Project Name: Boxted Solar Farm

Report Name: Response to LLFA Holding Objection

Project Number: P21-2950

This document provides a response to the holding objection received from Suffolk County Council as Lead Local Flood Authority to the proposed Boxted Solar Farm (application no: DC/23/O5127-FUL). The holding objection was received on the 15th November 2023 from Jason Skilton (Flood and Water Engineer). The LLFA's comments are enclosed at the end of this document. The comments detail that "the applicant needs to make a minor amendment to the surface water drainage strategy" and request that the submitted Flood Risk Assessment and surface water drainage strategy are re-submitted "referencing the LLFA Standing Advice – Solar Panels (PV) and Solar Farms (January 2022)". This standing advice document is enclosed at the end of this document.

River and Sea Flood Risk for - Site west of Tittle Hall Lane, Boxted, Bury St Edmunds, Suffolk. IP29 4TR.

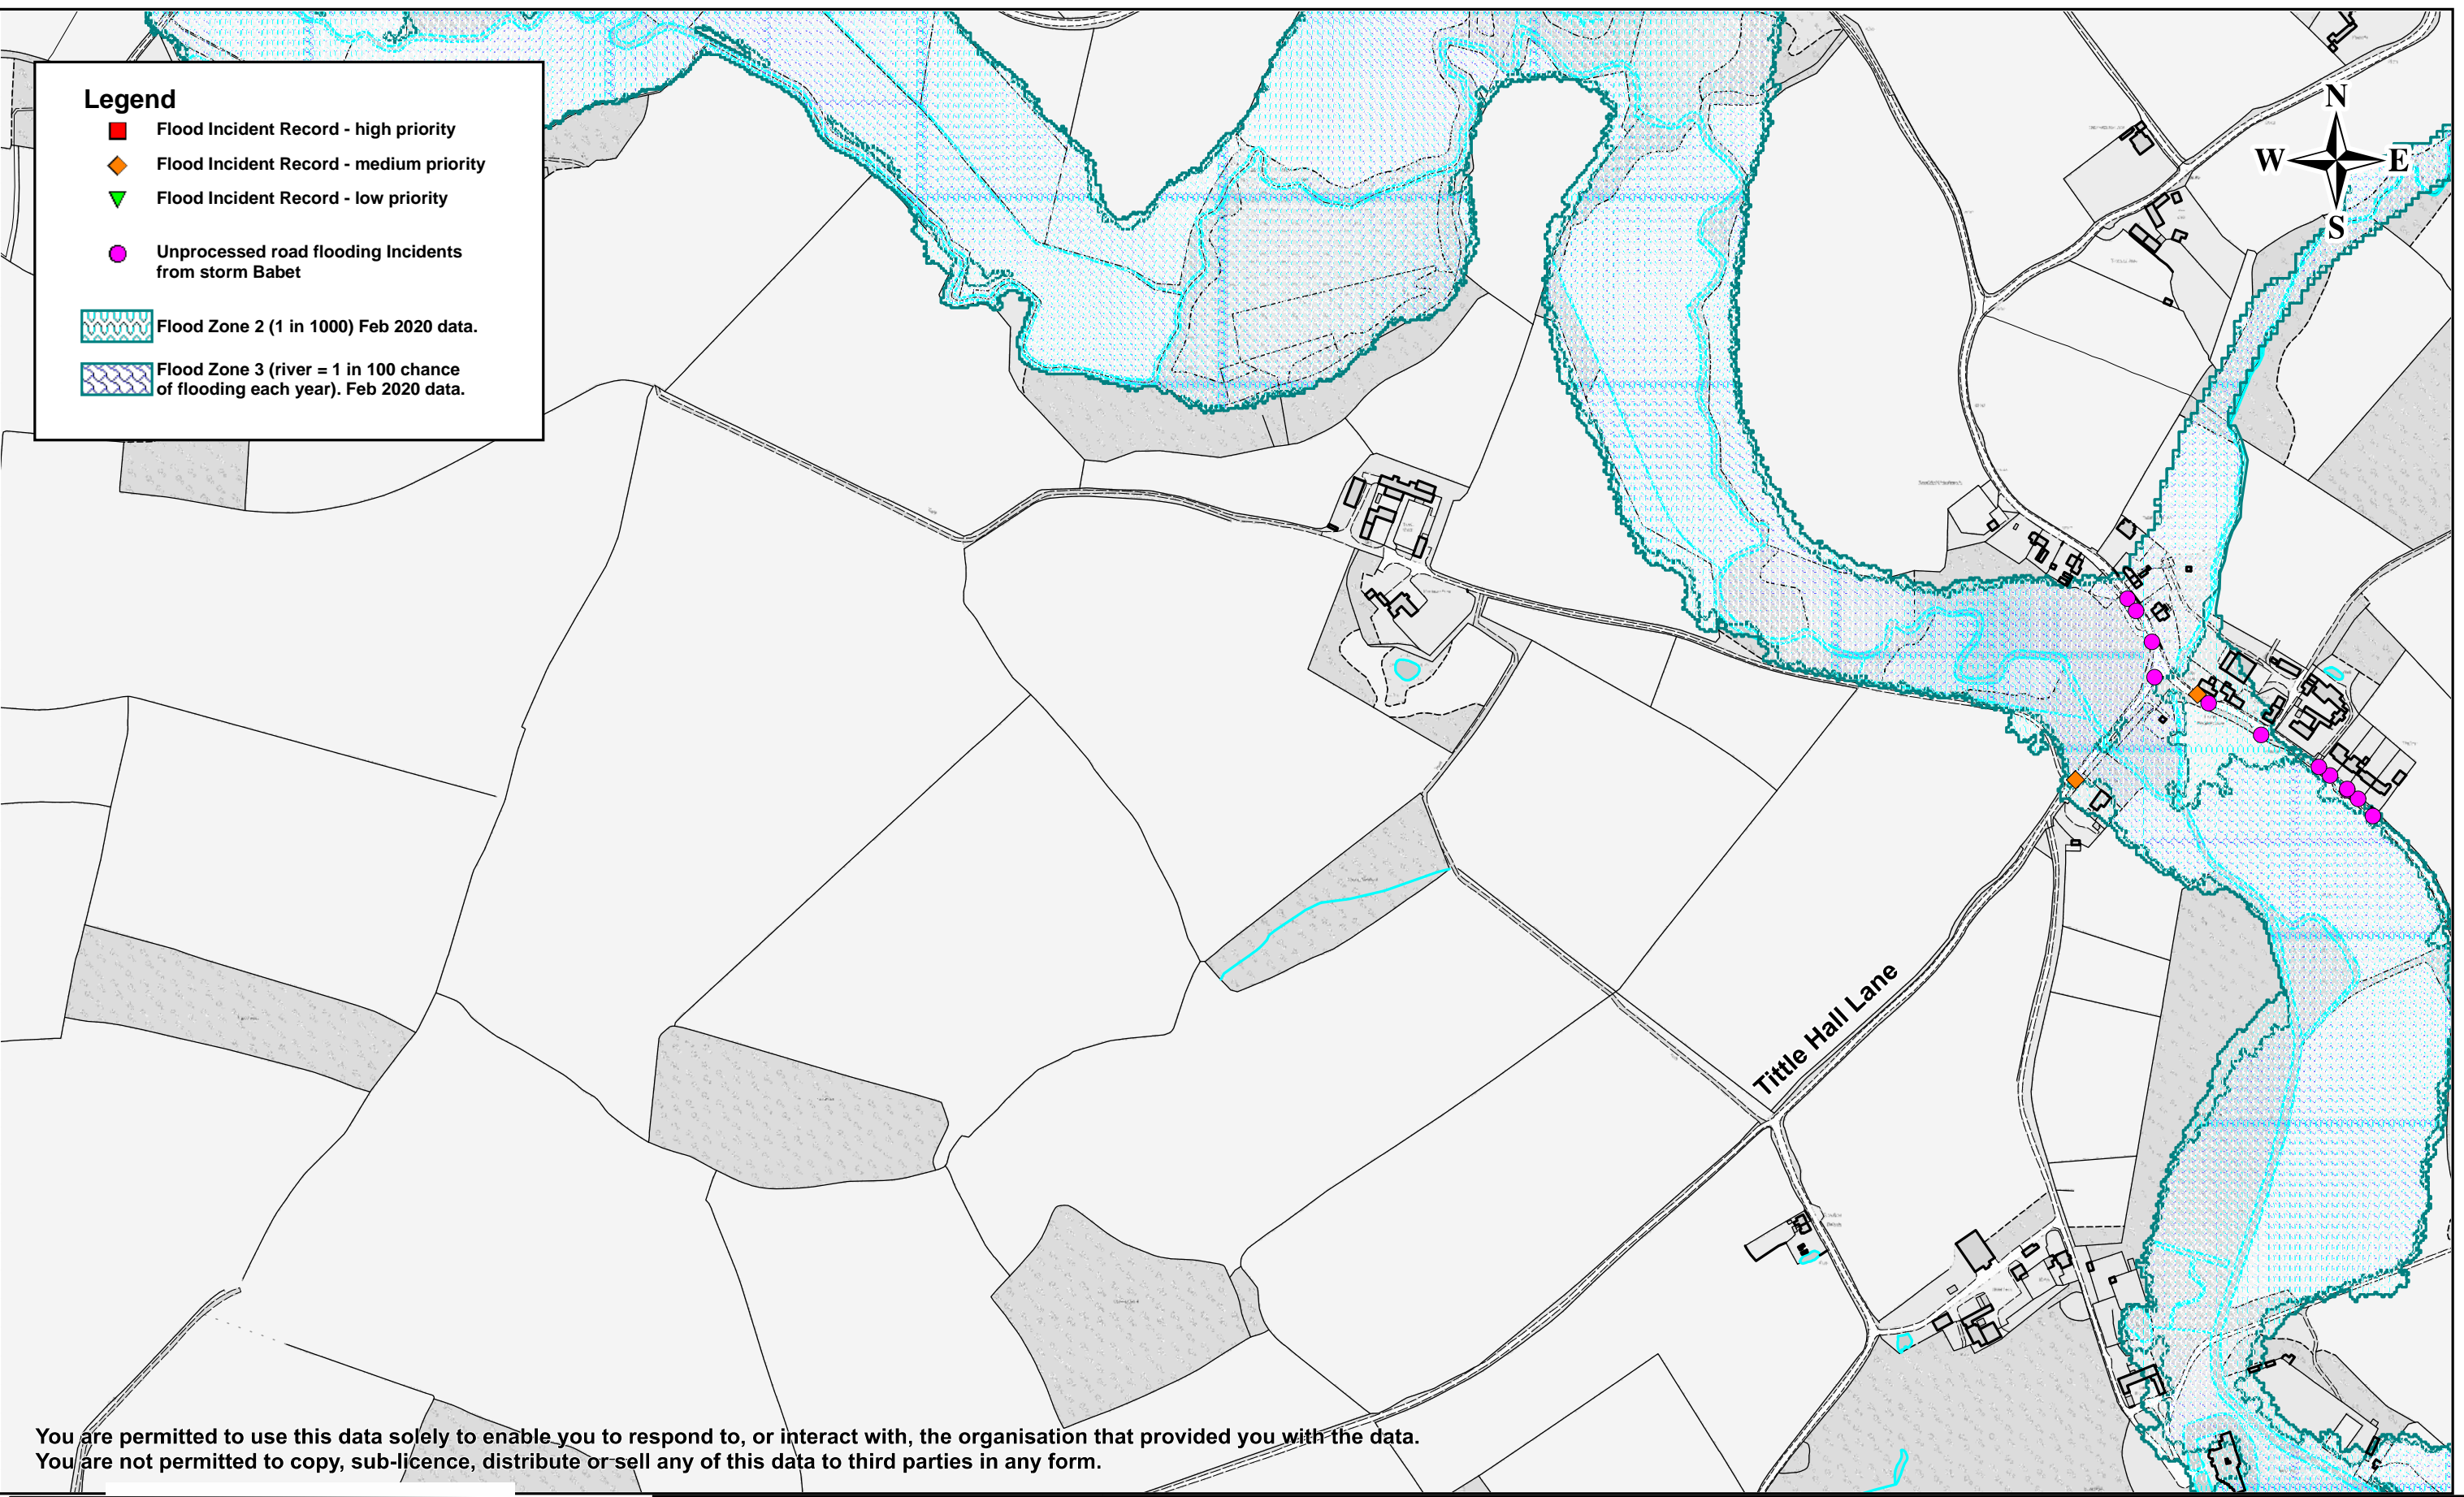
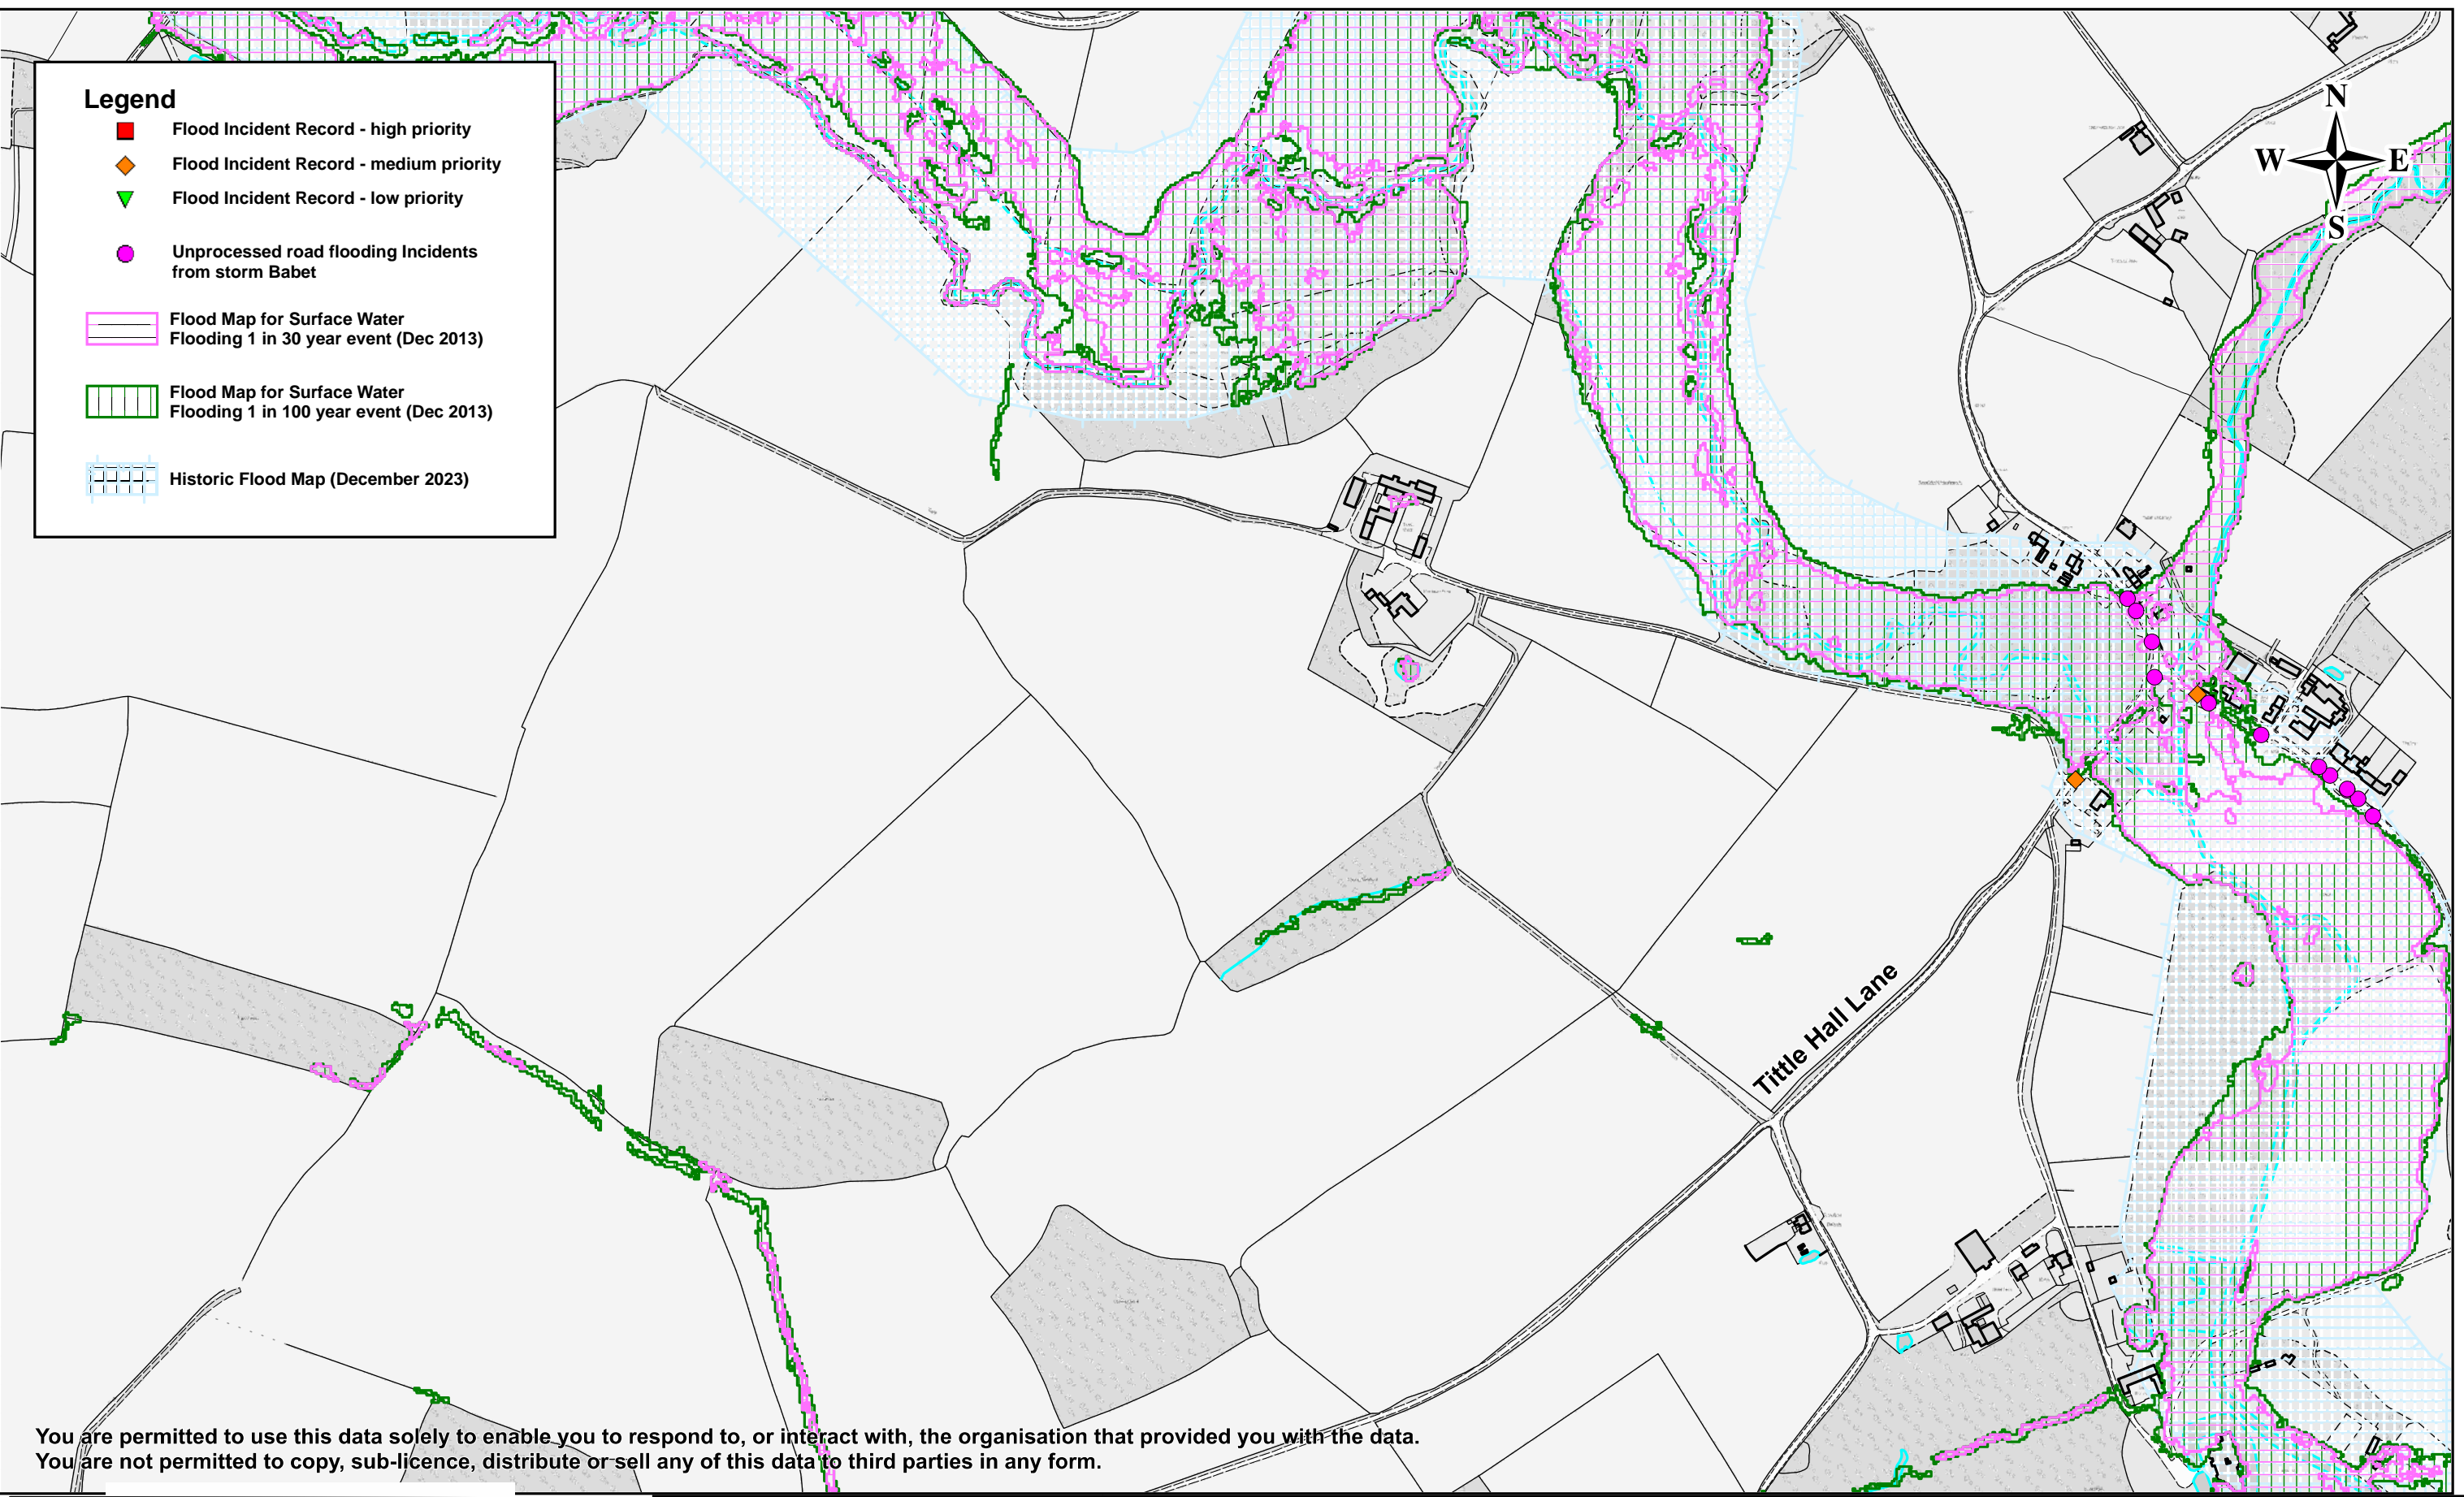
The LLFA’s standing advice (enclosed) details that “the FRA should include reference to any historical flood instances that have been recorded”. The submitted FRA (RO01v2-IN_P21-2950-FRA & Surface Water Drainage Strategy) assessed historic flood records held by the Environment Agency and included in the Babergh and Mid Suffolk SFRA (2020), concluding that there were no known historic flood events impacting the site. The assessment of LLFA historic flood records was requested during the meeting with the LLFA in February 2024. LLFA historic flood records were received in February 2024 and are enclosed at the end of this document. The LLFA’s historic flood records do not highlight any historic flood events that have impacted the site. There is a “flood incident record – medium priority” recorded just outside the site boundary.
